TITLE: SDP-04-003 WORK SESSION

Work Session on SDP-04-003, Amendment to Schematic Development Plan for MedImmune – Phase II and III, in the Quince Orchard Park development.

SUBJECT: Staff Analysis SDP-04-003, Amendment to Schematic Development Plan for MedImmune – Phase II and III, in the Quince Orchard Park development.

Schematic Development Plan
 LANDSCAPE PLAN
QUINCE ORCHARD PARK
 MEDIMMUNE - PHASES II and III
 Gaithersburg, MARYLAND

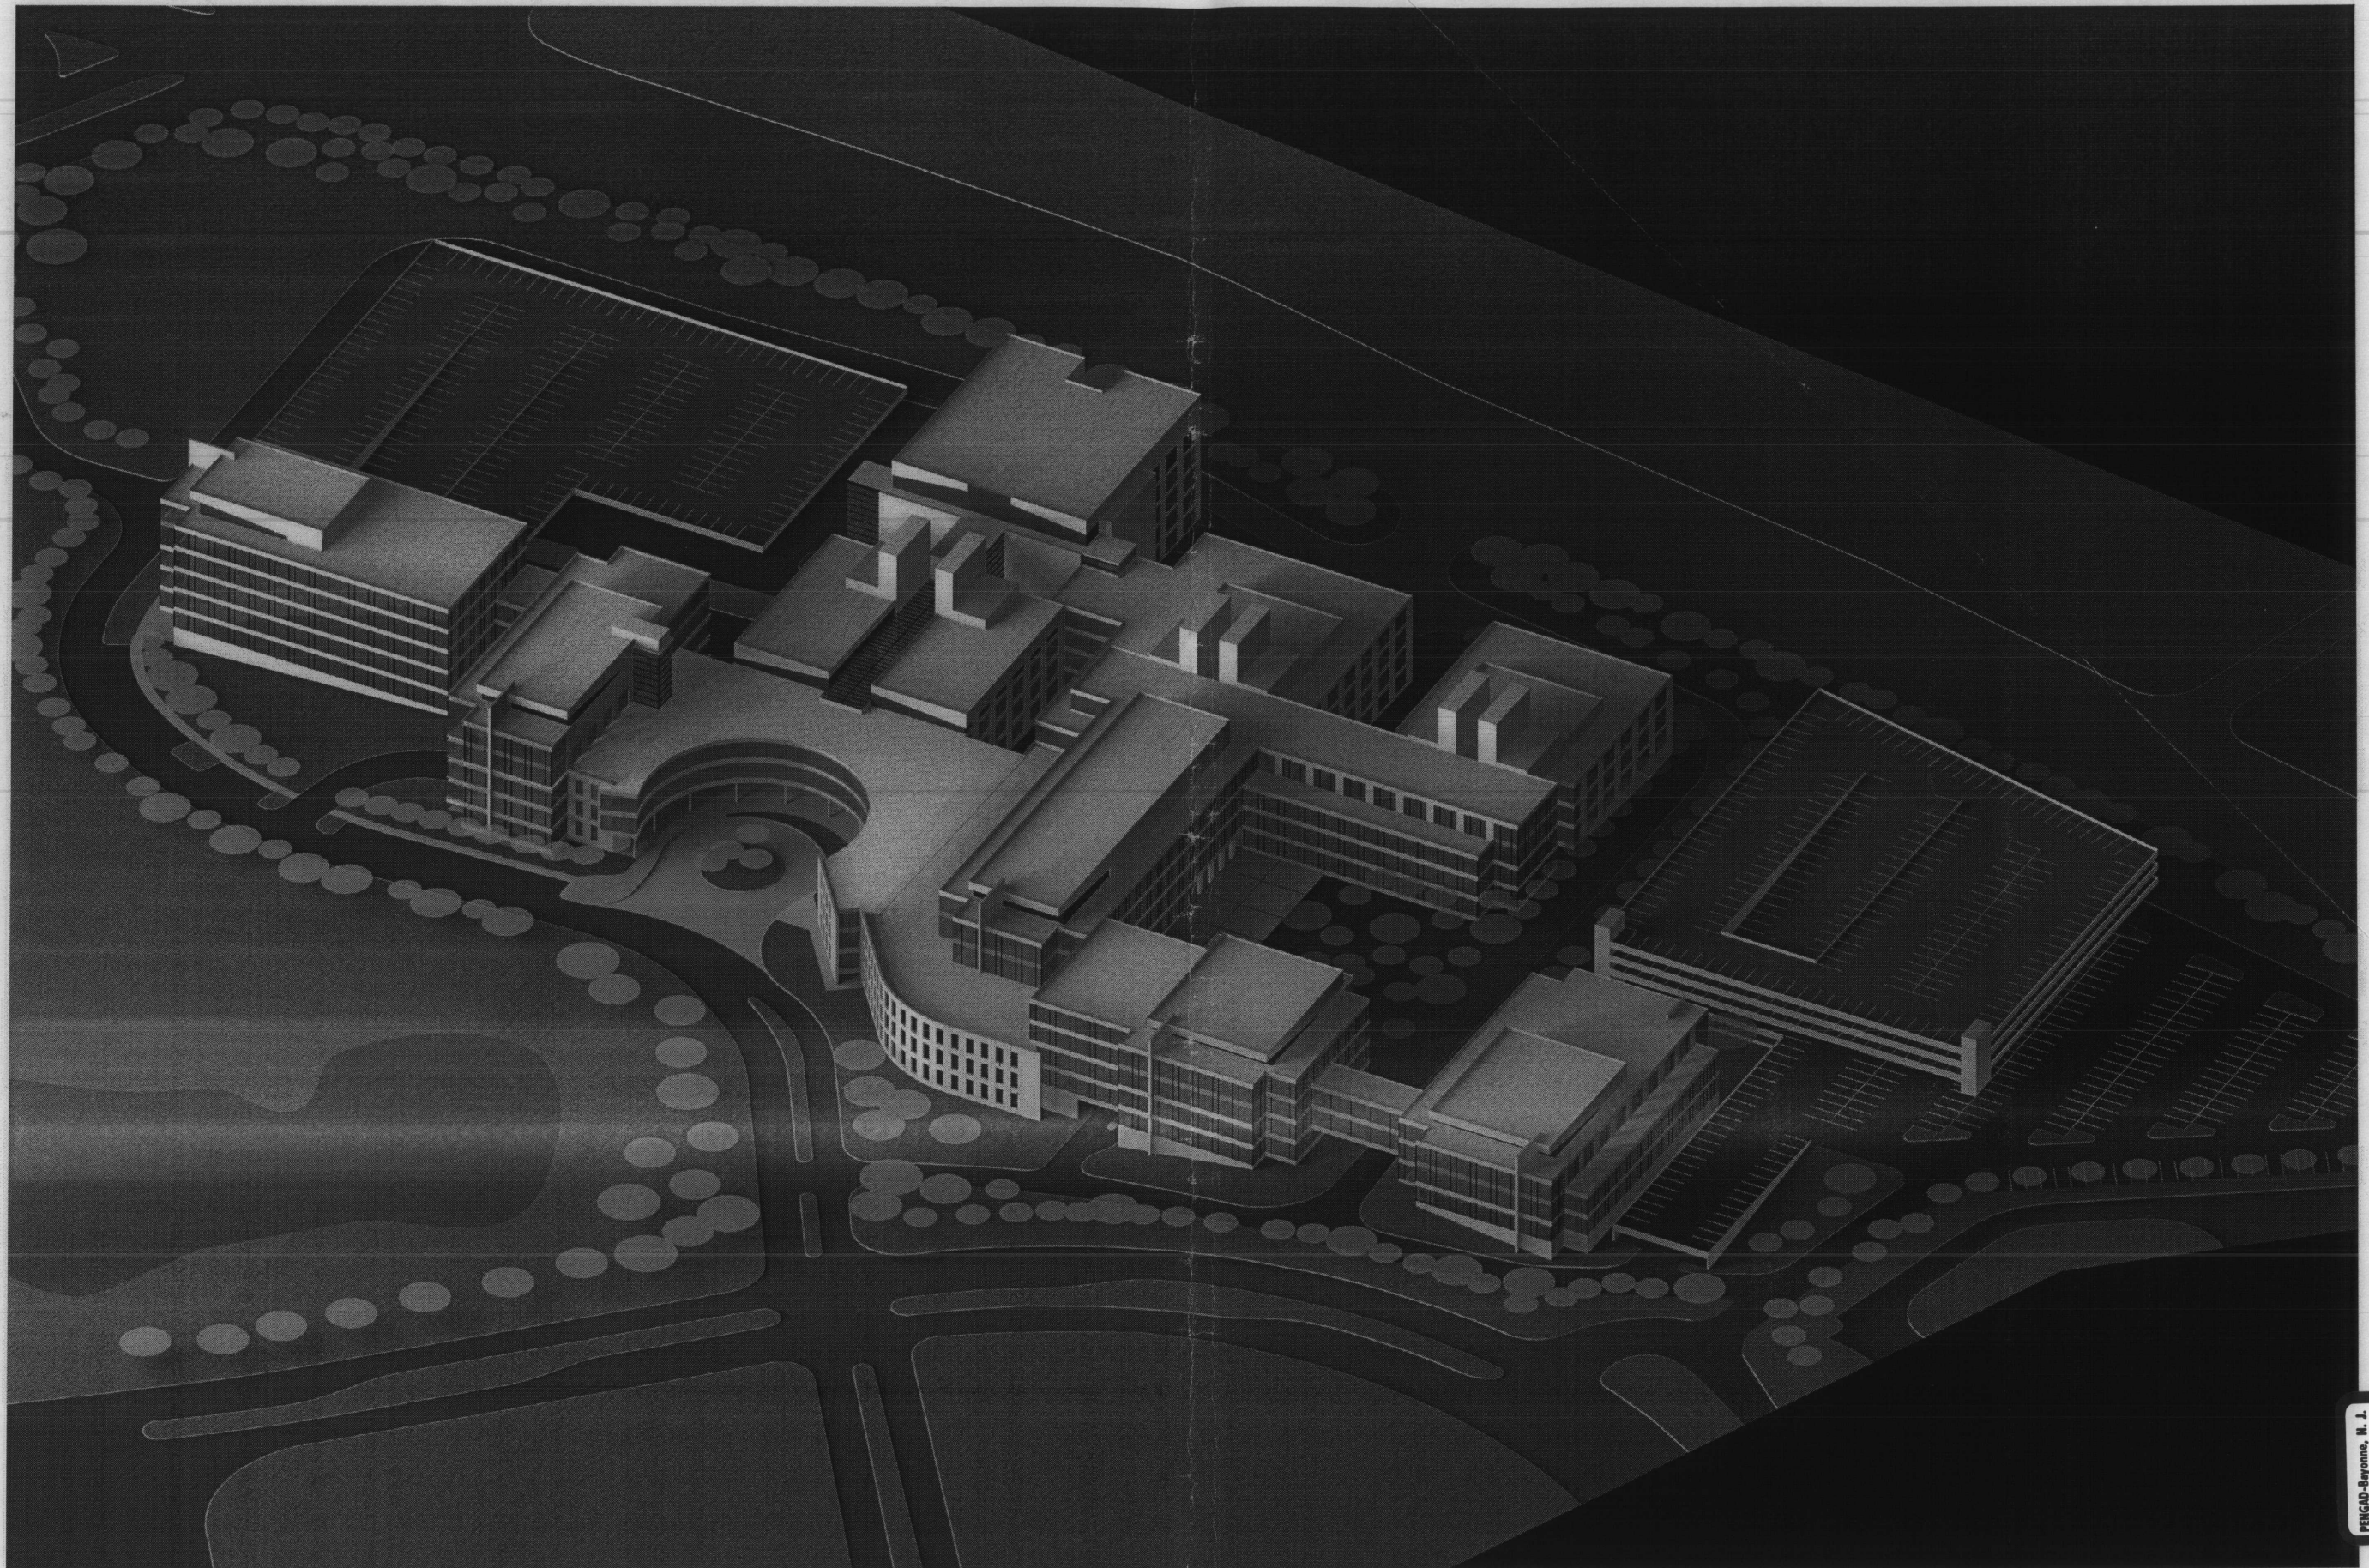
Staff is concerned with the need for the 105 surface parking space lot located at the west side of the site and recommends that these spaces not be provided. These spaces are located in an area that was previously open space and should remain as such. In addition, this area may be needed to meet storm water management and ground water recharge requirements. (See ***Stormwater Management***) Staff would recommend that after full build-out of the MedImmune development, the applicant may submit revised plans to the Planning Commission requesting the additional surface parking showing that the need for the spaces, that stormwater management is not affected, and that all open space and forest conservation requirements are not affected.

The applicant has removed required plantings, from previously approved site plans, along Great Seneca Highway. Staff would recommend that the applicant replace these plantings, provide additional trees, and complete the landscaping along the length of Great Seneca Highway at the time of final site plan.

7. Applicant to denote the excess 115 surface parking spaces along the west side of the site as future parking. A note should be added to the plan that states, "After full build-out of the MedImmune development, the applicant may

submit revised plans to the Planning Commission requesting the additional surface parking demonstrating that there is need for the parking spaces, stormwater management is not affected, and all open space and forest conservation requirements are not affected, otherwise the area should be maintained as open space.”
